EPA-450/3-80-033b
June 1982

VOC Fugitive Emissions in Synthetic Organic Chemicals Manufacturing Industry—

Background Information for Promulgated Standards

Background Information
Final Environmental Impact Statement for
Equipment Leaks of VOC in the Synthetic Organic
Chemical Manufacturing Industry

Figure 4-1. Fraction of valves operating improperly at the end of the initial year under leak detection and repair programs of various monitoring intervals for an average SOCFI unit.

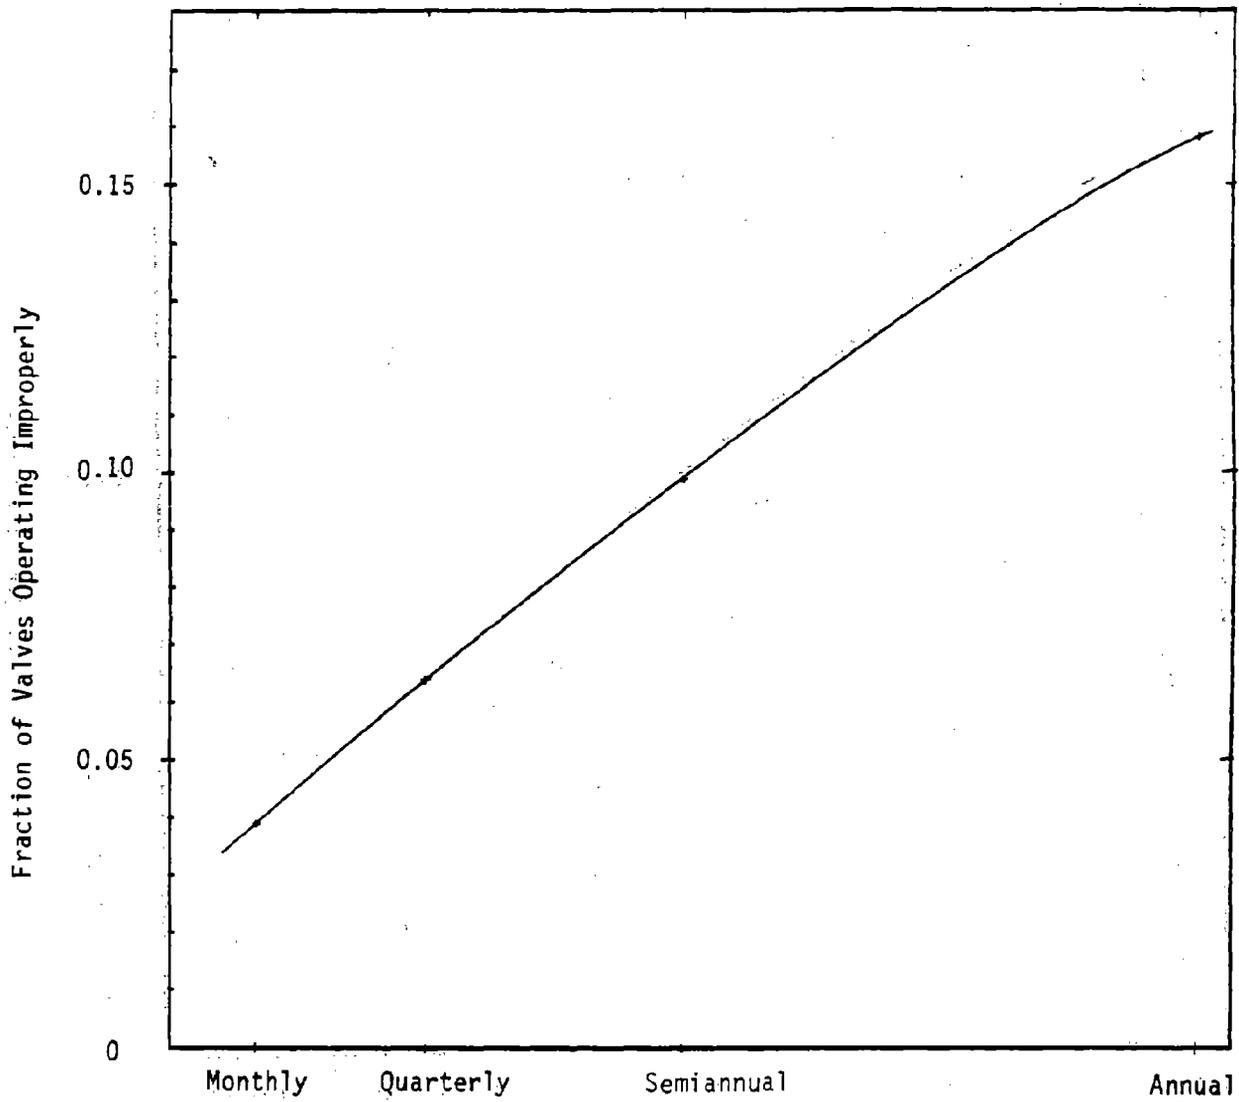
The second assumption being challenged is the relationship of valve leak occurrence to valve leak recurrence. As explained in the preamble to the proposed regulation (46 FR 1146), the proposed monitoring program for valves included an allowance to monitor valves that leak infrequently on a quarterly basis. This was based on the assumption that recurrence of leaks is a significant contributor to the total number of leaks. Data from SOCFI fugitive emission studies do not conclusively confirm this assumption.

Since proposal, analysis of the results of the SOCFI maintenance study (IV-A-7) led to the development of a new model describing leak detection and repair programs. This model is described in detail in Docket Item No. IV-A-22 and in the recently distributed AID (III-B-2). The results of the model evaluating various possible leak detection and repair programs for valves and using inputs from the SOCFI maintenance study are shown in Figure 4-1. The fraction of valves operating improperly (occurring, recurring, and unrepairable) is presented as a function of monitoring interval.

Valve leak occurrence and recurrence rates are shown in Table 4-3. These numbers indicate the difference between occurrence and recurrence rates.

Figure 5-1. Example for process unit definition.

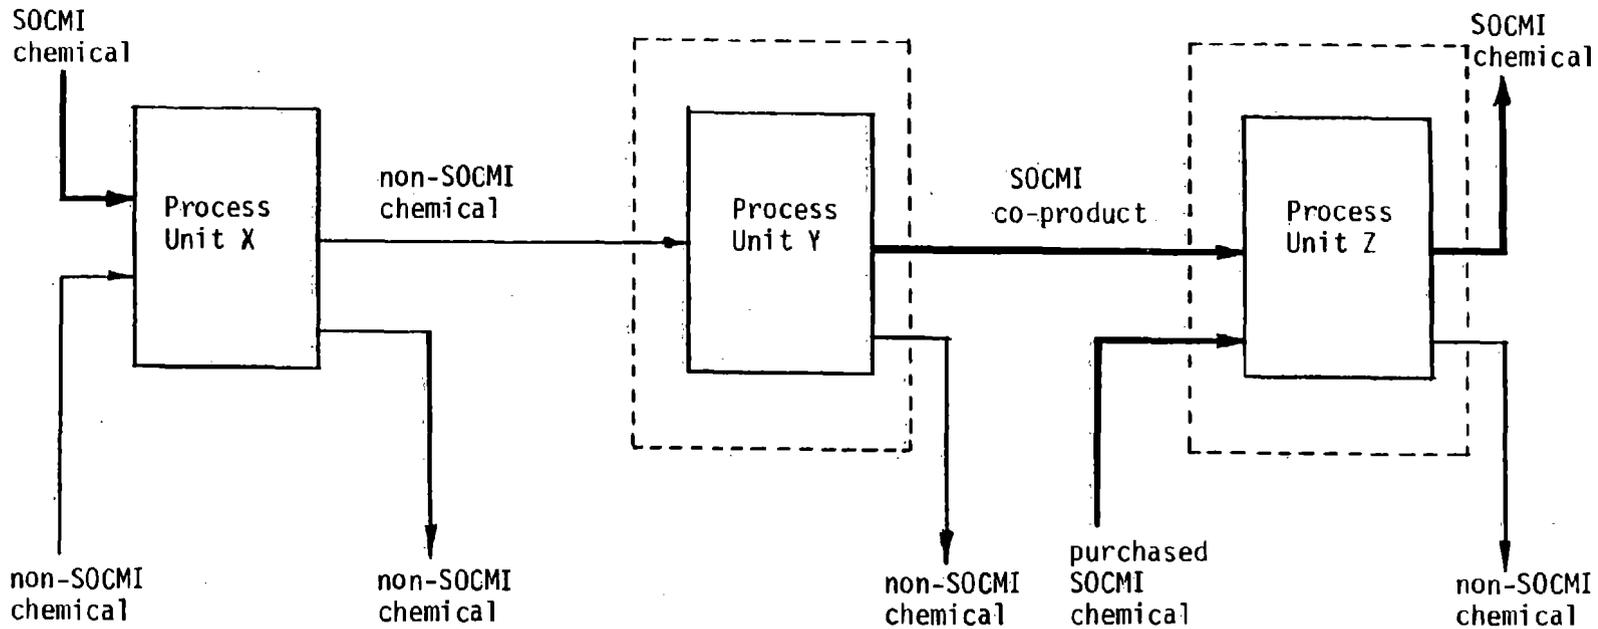
Another commenter (IV-D-15) cited a potential problem in defining when an upstream process unit is an affected facility. He cited as an example a crude unit in a petroleum refinery which produces intermediate refinery streams which may contain 10 percent or more VOC per the proposed ASTM methods. These streams may feed a unit which will eventually produce a SOCFI chemical. In such instances it was not clear to the commenter which streams would be covered. He recommended that only the downstream unit be covered.

The SOCFI NSPS for fugitive VOC sources regulate process units that produce chemicals that are either photochemically reactive substances, use photochemically reactive chemicals as additives or reactants in the production process, or have photochemically reactive co-products. The chemicals covered by these standards are listed in §60.489. Therefore, if the intermediate product is one of the chemicals listed in §60.489, the unit producing it is covered by the standards. If the downstream unit also produces one or more chemicals on the list, it will also be covered by the standards.

The following example is offered for purposes of clarification. Figure 5-1 shows a configuration of a hypothetical petroleum refinery or chemical plant. In this hypothetical complex, there are three processes. Process X uses SOCFI and non-SOCFI raw materials to produce a non-SOCFI chemical and non-SOCFI co-products. Process unit X would not be covered by the final SOCFI standards because SOCFI chemicals are not produced.

Figure A-3. Comparison of emission factors computed for leaking valves in gas service.

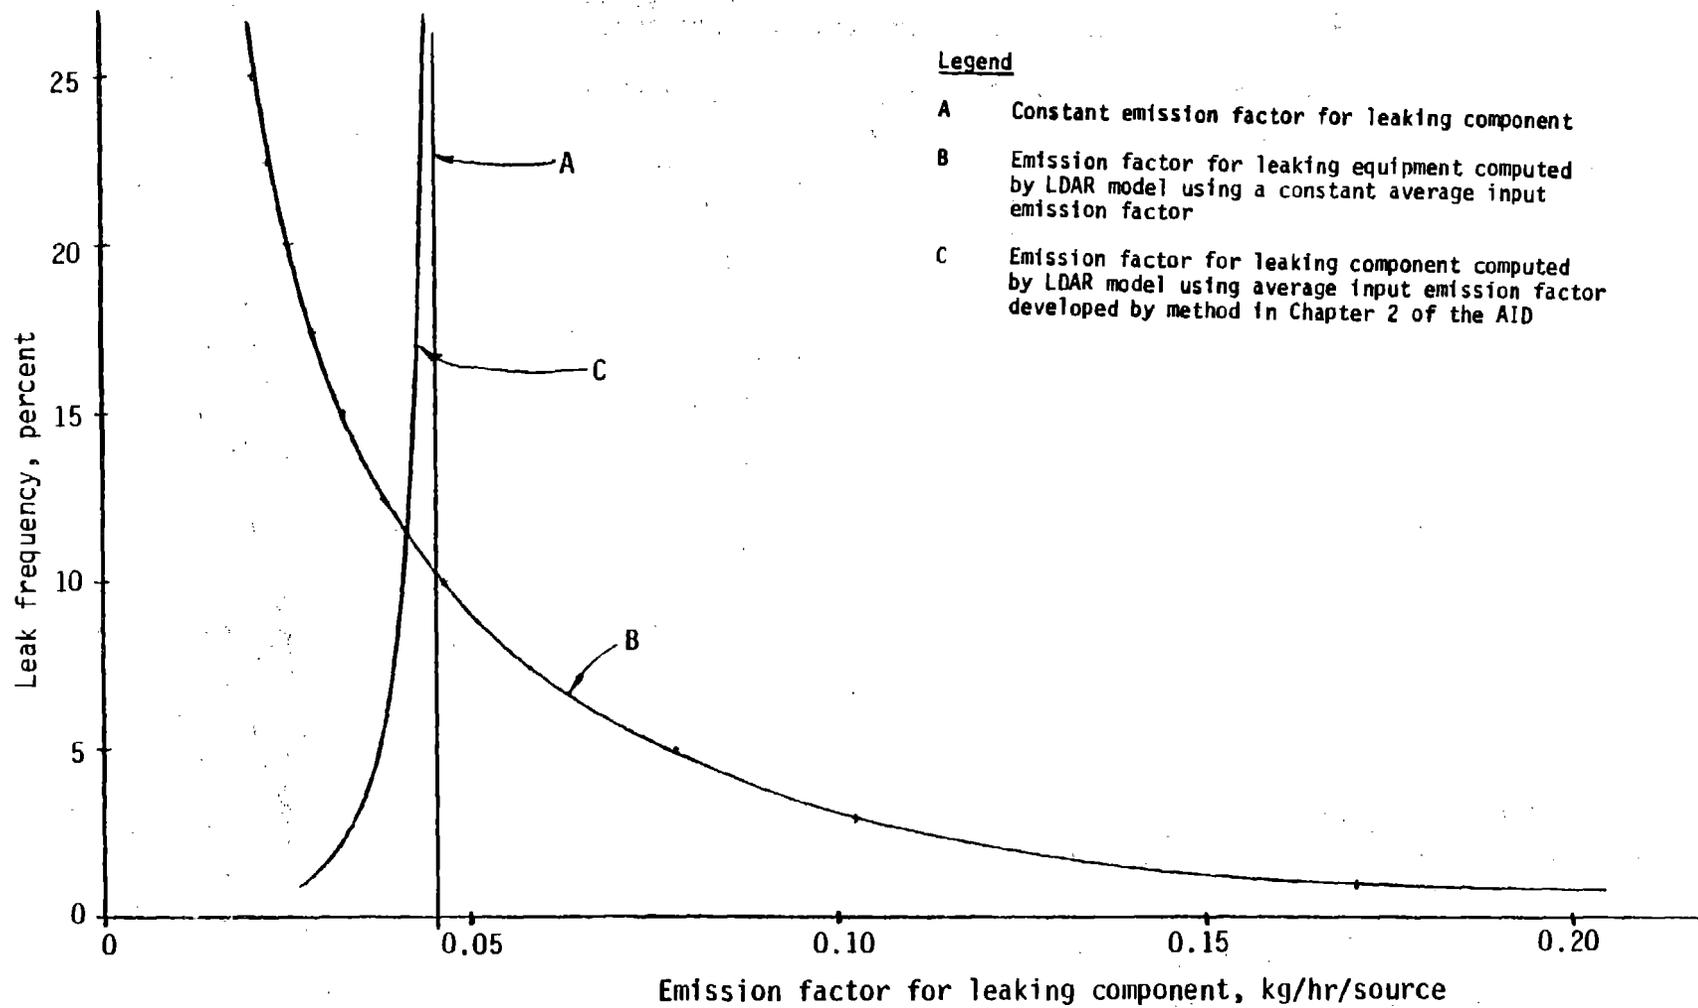
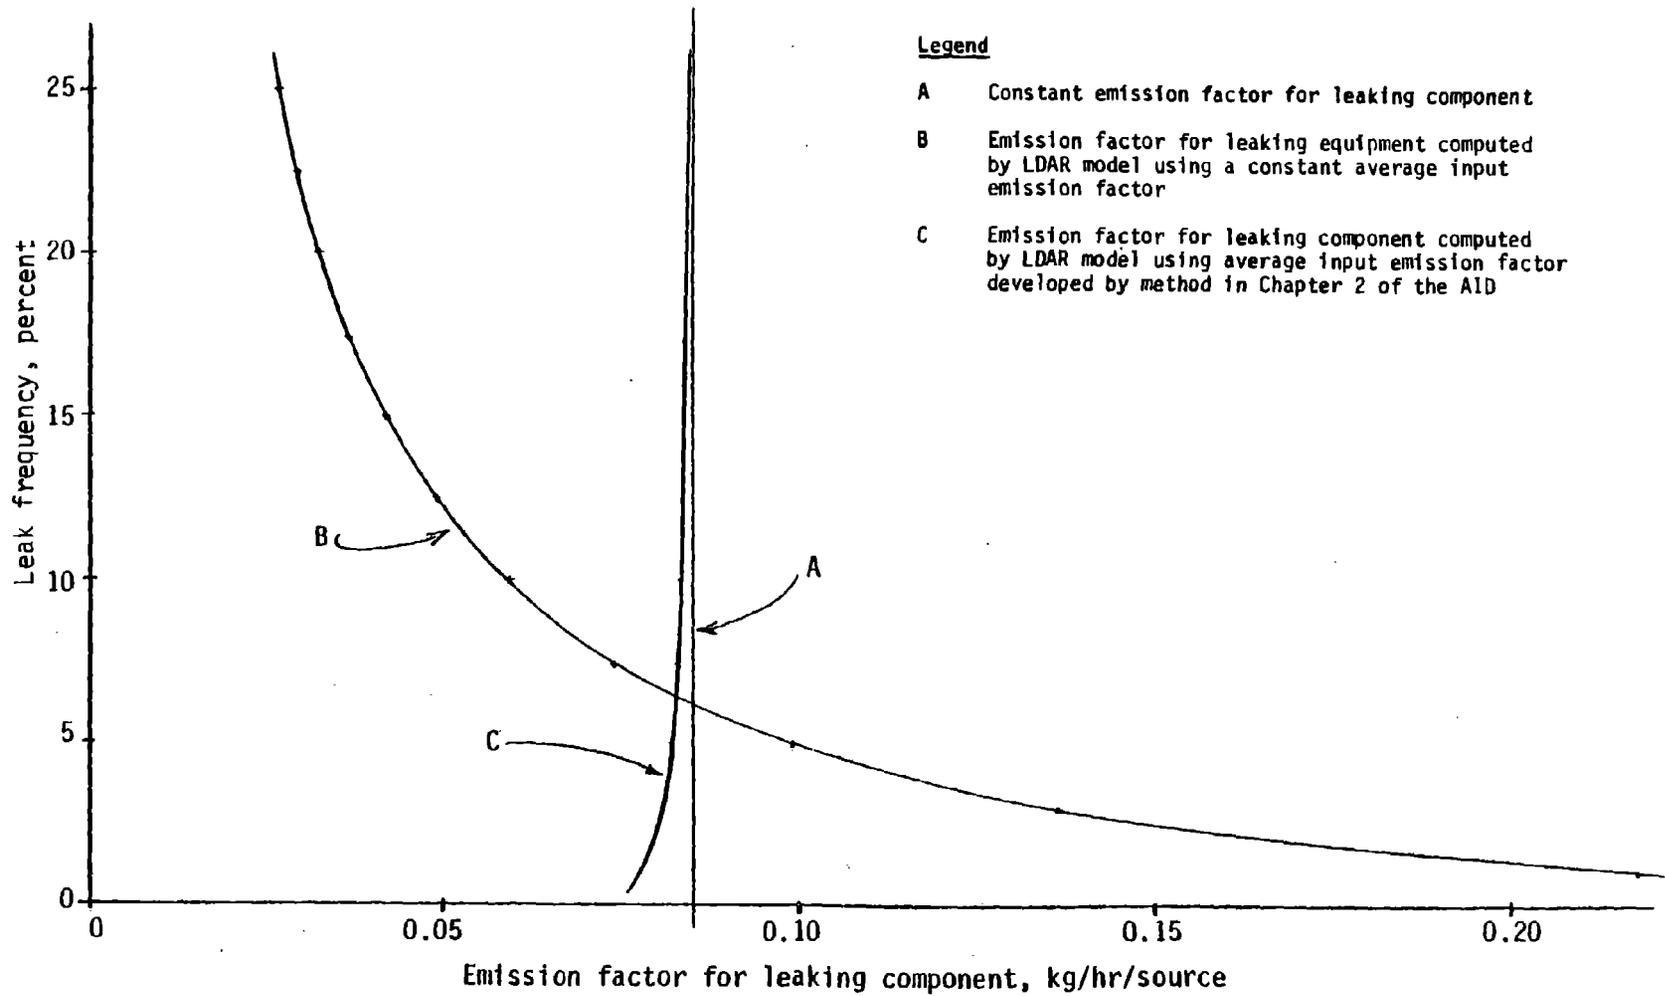
Comment: Two commenters (IV-N-9; IV-N-10) objected to the comparison of the LDAR model results to the ABCD and modified-ABCD model results. One (IV-N-9) called the comparison an apples and oranges comparison. The other (IV-N-10) said that, instead, the validity of the LDAR assumptions, inputs, and results should be investigated separately.

The LDAR model's approximation of a constant emission factor for leaking components is shown in Figures A-3 and A-4 for valves in gas and light liquid service. Each figure presents three curves for the emission factor for leaking components determined by different methods. Curve "A" is the constant emission factor used in the development of average input emission factors. This is the value presented in Chapter 2 of the AID. Curve "B" represents the LDAR model approximation of the emission factor for leaking components assuming a constant average input emission factor. This curve is similar to the one presented by one of the commenters (IV-N-10) in Figures A-1 and A-2. Finally, curve "C" is the LDAR model approximation of the constant emission factor for leaking components. The average input emission factors used in generating this curve were determined by the method presented in Chapter 2 of the AID, based on a constant emission factor for leaking components (Curve "A") and a leak frequency.

In comparing curves "A" and "C" there is a small deviation from linearity noted for curve "C." The deviation is the result of the relationship between the emission factor for leaking components and the emission factor for nonleaking components assumed in the LDAR model. As seen in the figures, however, this simplifying assumption is justified since the resulting emission factors for leaking components are a close approximation of those used to generate the average input emission factors.

Figure A-7. Comparison of valve occurrence rates assuming a linear relationship and an exponential model.

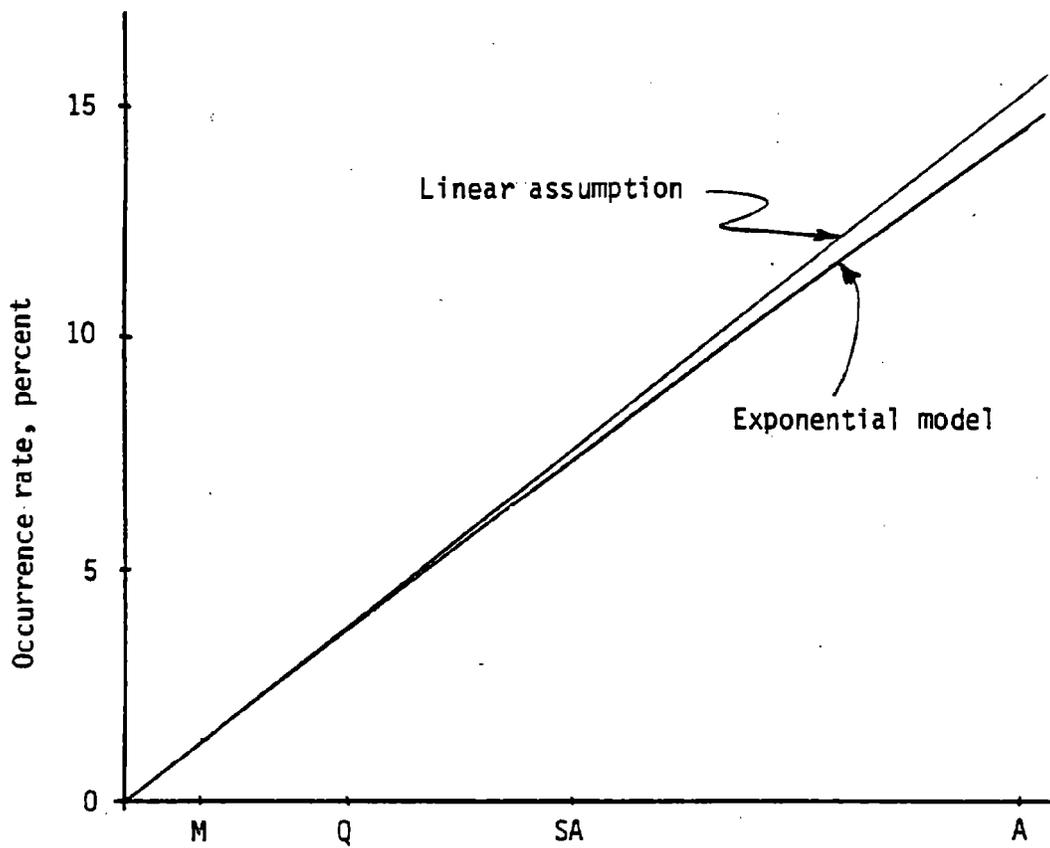
Comment: One commenter (IV-N-7) felt that the main problem with the model is in the assumption for occurrence and recurrence rates. The rate appeared unrealistically high to the commenter who felt that the rates should not be extrapolated linearly. He found the assumption of the same number of leaks occurring in the first and twelfth months unrealistic. He attributed the negative efficiencies associated with annual programs to the assumption of linearity.

Response: The occurrence and recurrence rates used in the AID for valves were developed in the Maintenance Study (IV-A-10). An exponential model was fit to the experimental data to develop the estimates. The results of this procedure for valves are compared to a linear extrapolation of the quarterly occurrence rate in Figure A-7. (The rates used in the LDAR model producing

the results in the AID were linearly approximated from the quarterly rate.) As noted by the small difference between the estimates, even at an annual monitoring interval, an assumption of linearity for valves is a close approximation of the modeled occurrence rate. Based on this small difference, an assumption of linearity for the valve leak occurrence rate is not the reason for the negative efficiencies associated with annual monitoring programs. In fact when the LDAR model was reexecuted using the corrected occurrence rate for annual monitoring, a negative efficiency still resulted for valves in light liquid service (IV-B-23).
